**Response to Portion of NRC Request for
Additional Information Letter No. 270
Related to ESBWR Design Certification Application**

Containment Systems

RAI Numbers 6.2-140 S03 and 6.2-185 S01

**Response to Portion of NRC Request for
Additional Information Letter No. 270
Related to ESBWR Design Certification Application**

Figure 6.2-14e5a. Drywell, Wetwell and RPV Pressures (720 hr)

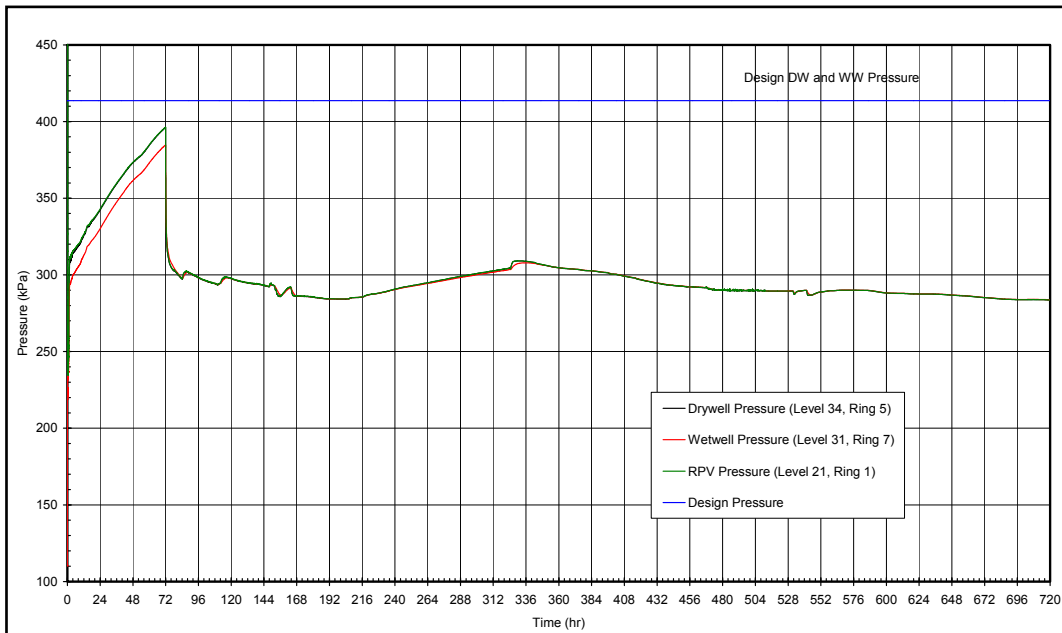
GEH's response to RAI 6.2-140 S02 is acceptable. Update the ESBWR DCD to include the response to part (A) of the RAI.

DCD Tier 2, Subsection 6.2.1.1.3.5.1, will be revised as requested to include the RAI 6.2-140 S02 response, part (A), including the corresponding containment pressure and temperature figures as new DCD Tier 2, Figure 6.2-14e5a and Figure 6.2-14e6a.

DCD Tier 2, Subsection 6.2.1.1.3.5.1, will be revised, and DCD Tier 2, Figure 6.2-14e5a and Figure 6.2-14e6a will be added, as noted in the attached markup.
